SECTION 00 91 15

ADDENDUM NUMBER 6

- 1.01 DATE: APRIL 6, 2021**
- 1.02 PROJECT: WELCOME CENTER**
- 1.03 PROJECT NUMBER: DCM NO. 2020604**
- 1.04 OWNER: ALABAMA A&M UNIVERSITY**
- 1.05 ARCHITECT: NOLA | VAN PEURSEM ARCHITECTS, PC**

SECTION H
SCALE 3/4" = 1'-0"
TYP. AT EXTERIOR SLAB

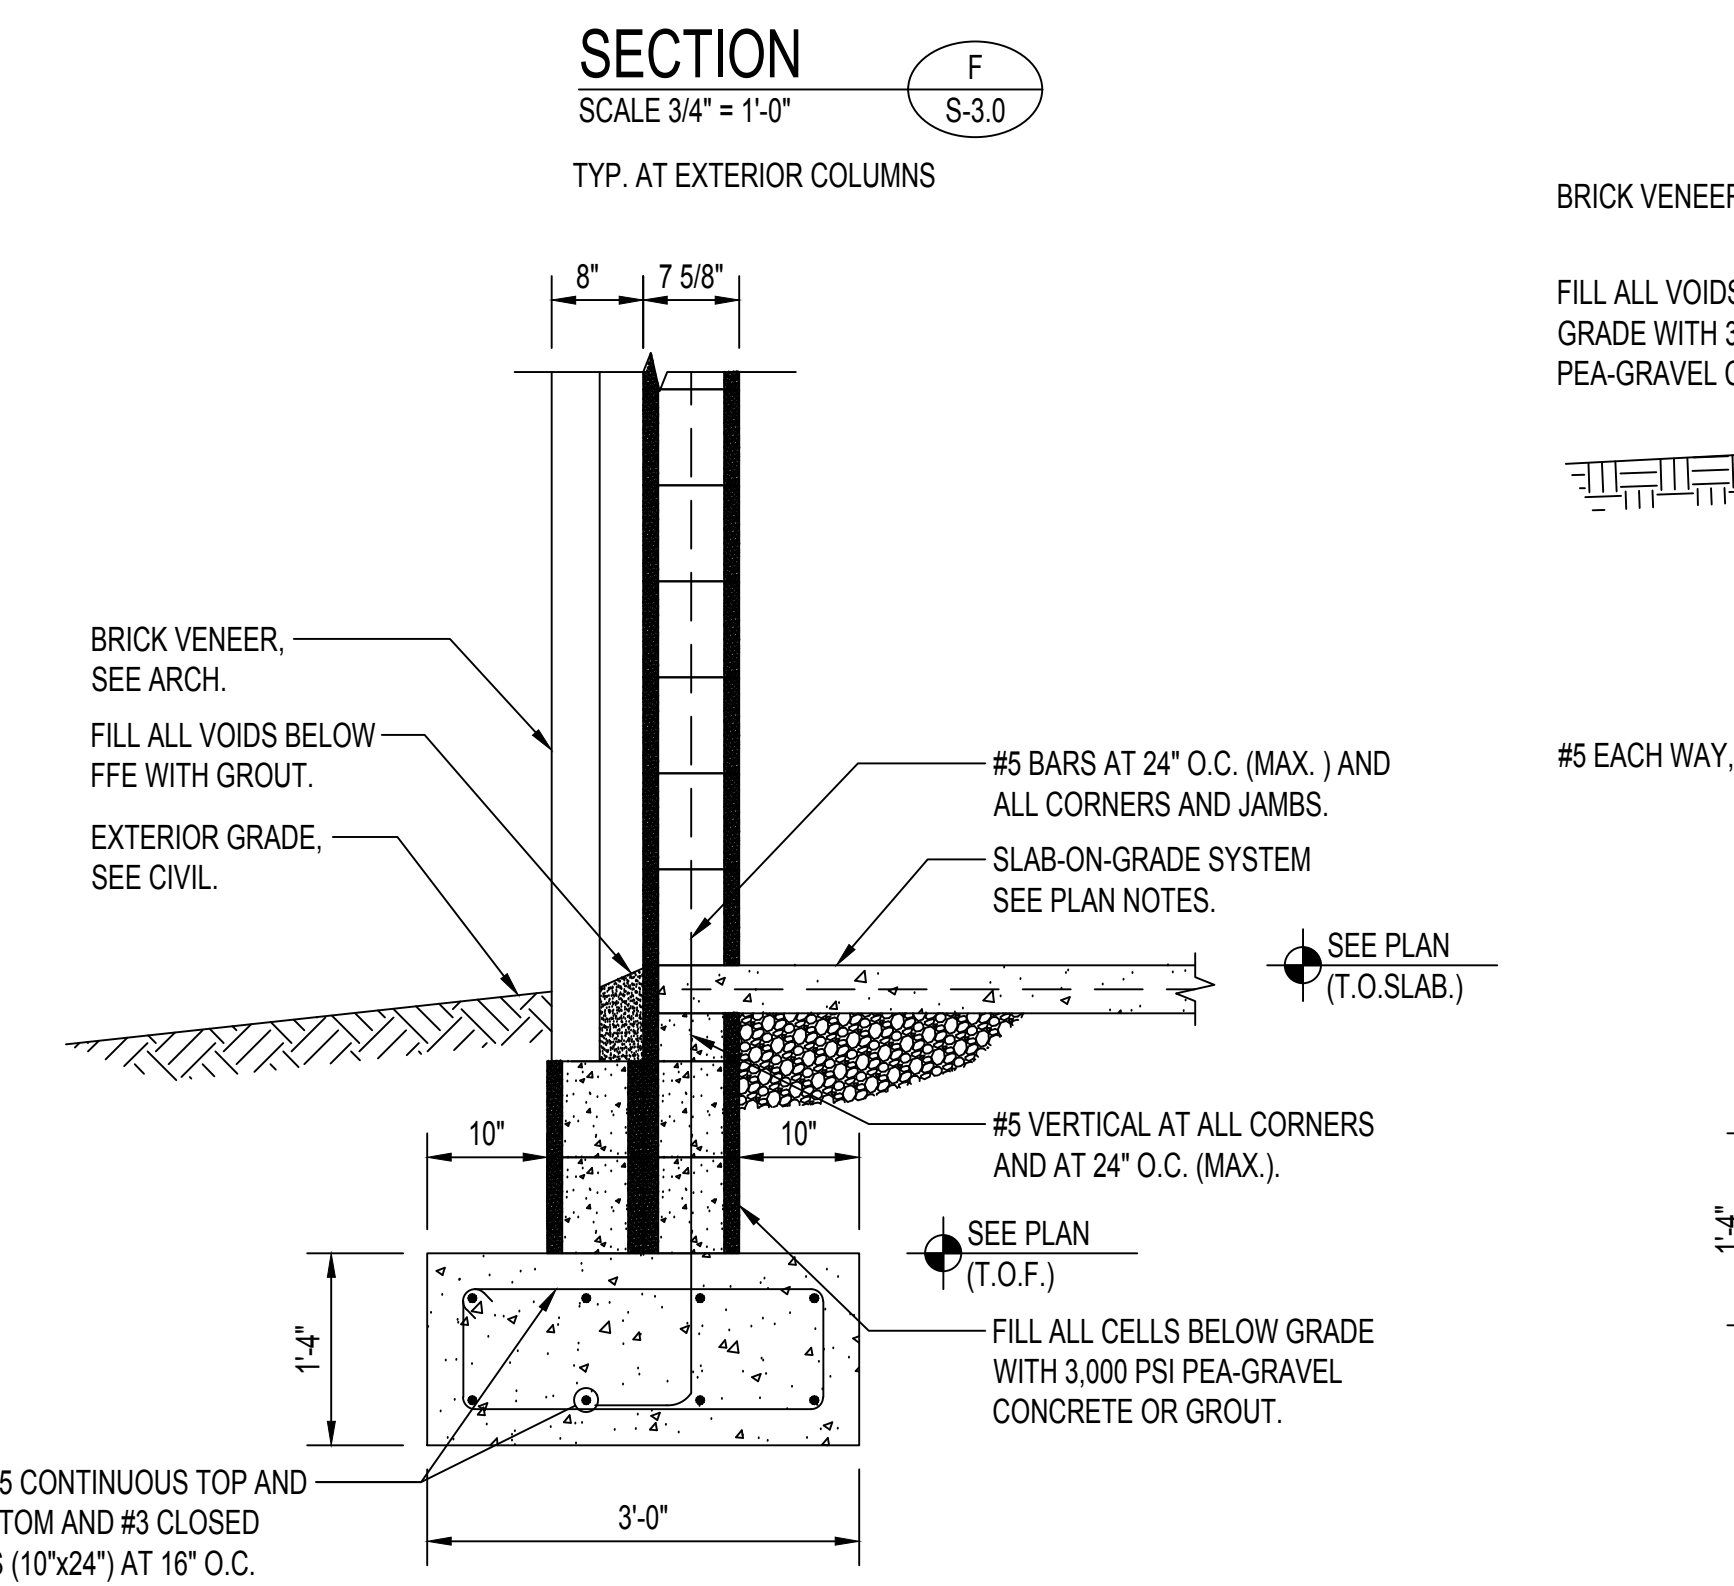
4.23 SHEET S-3.1 – WALL SECTIONS:

- A. Replace this sheet in its entirety. Revisions include the following:
1. Added Sections J/S-3.1 & K/S-3.1.
 2. Revised dimensions on detail F/S-3.1
 3. Added contractor’s option to use beams at Section H/S-3.1

SHEET NUMBER
E-1.0
OF

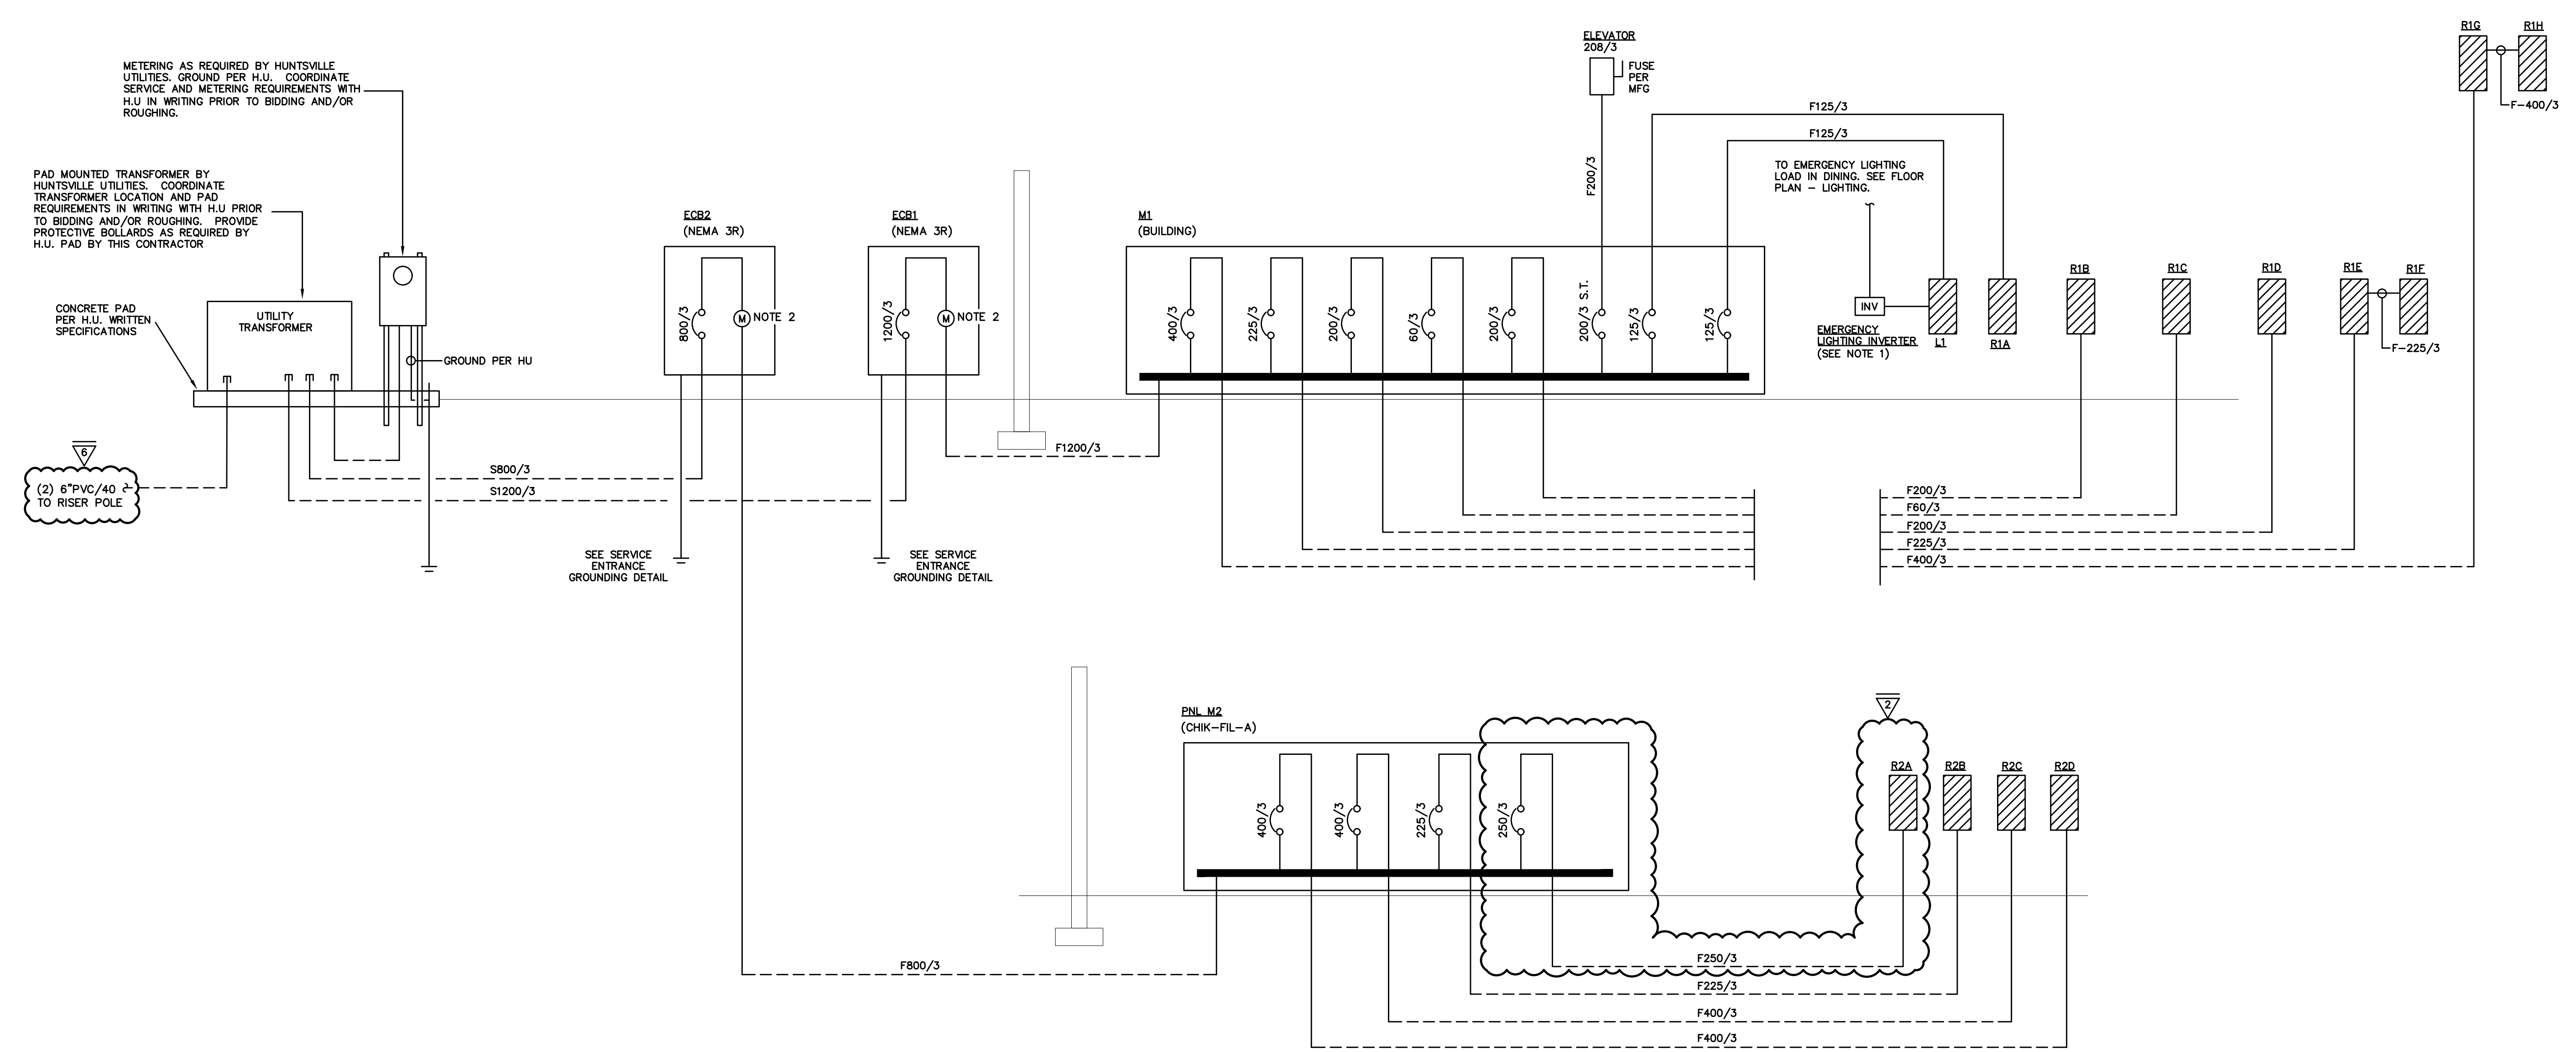
4.25 SHEET E-1.0 – WALL SECTIONS:

- A. Replace this sheet in its entirety. Revisions include the following:
1. Security legend has been revised. See attached revised drawings.
 2. Add descriptions for ceiling speaker and ceiling subwoofer. See attached revised drawings.
 3. New fire alarm system (fire alarm control panel, fire alarm devices, fire alarm cabling, fire alarm system set-up and programming) to be furnished and installed under base bid. See attached revised drawings.

SHEET NUMBER
E-3.0
 OF

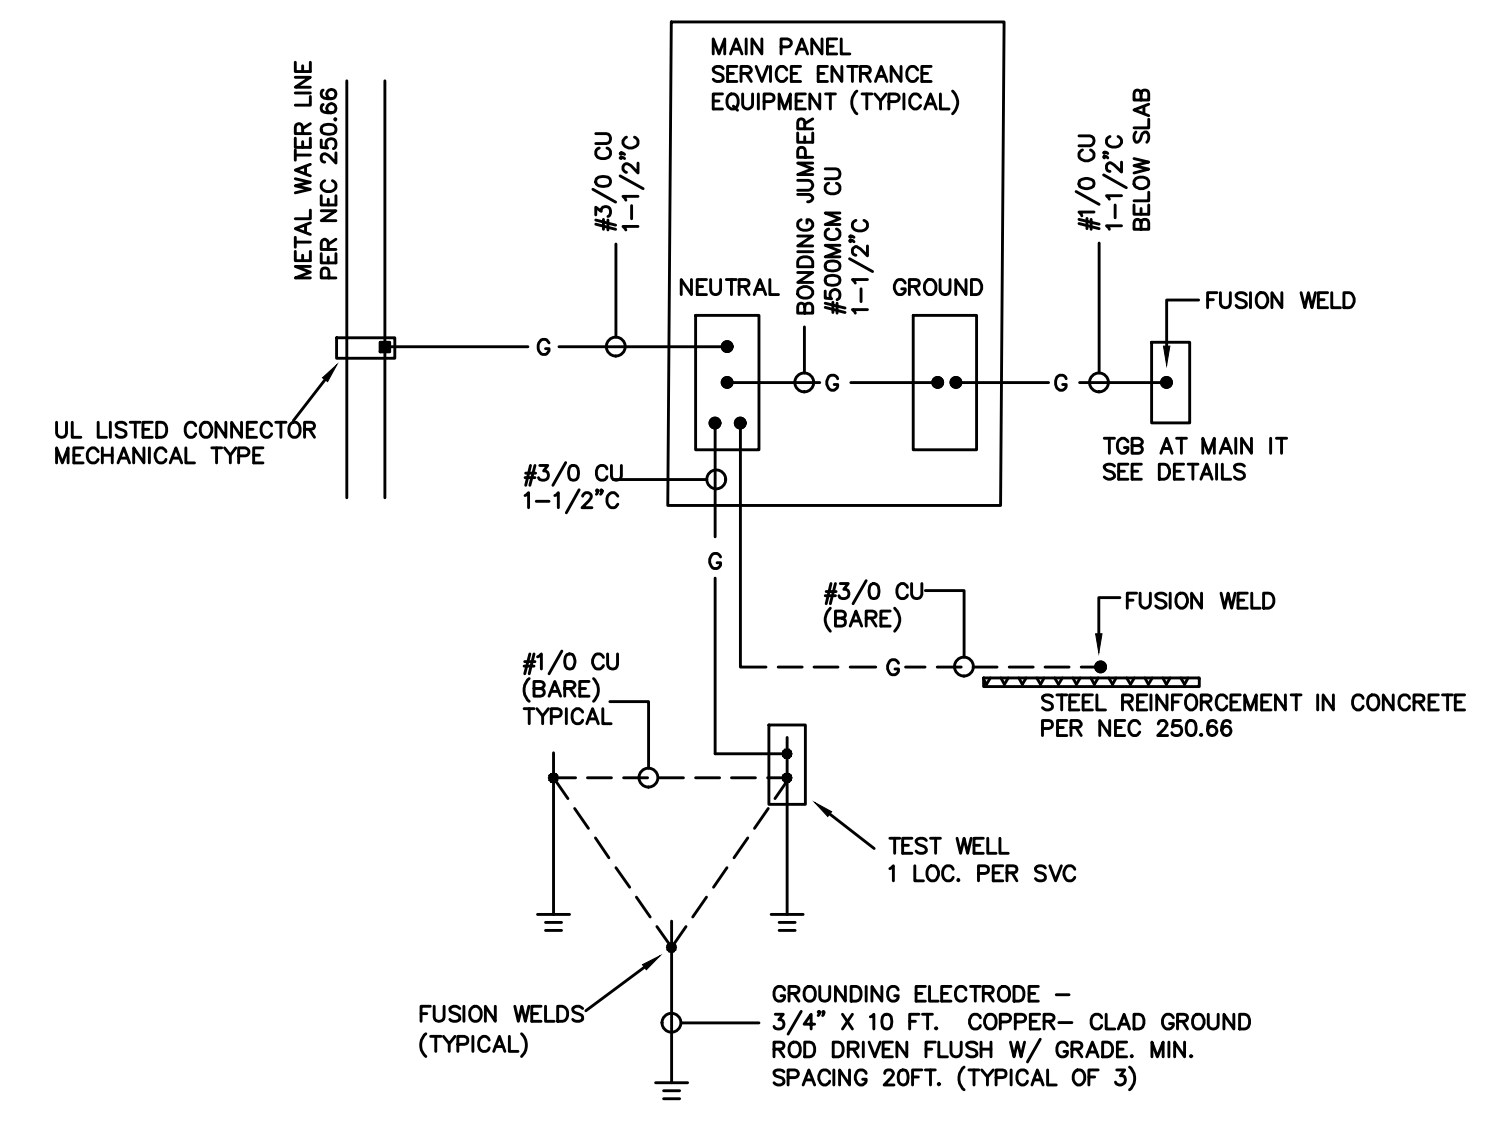
4.26 SHEET E-3.0 – ELECTRICAL SINGLE LINE DIAGRAMS:

- A. Replace this sheet in its entirety. Revisions include the following:
1. Added note to show new utility transformer to be fed from new riser pole.
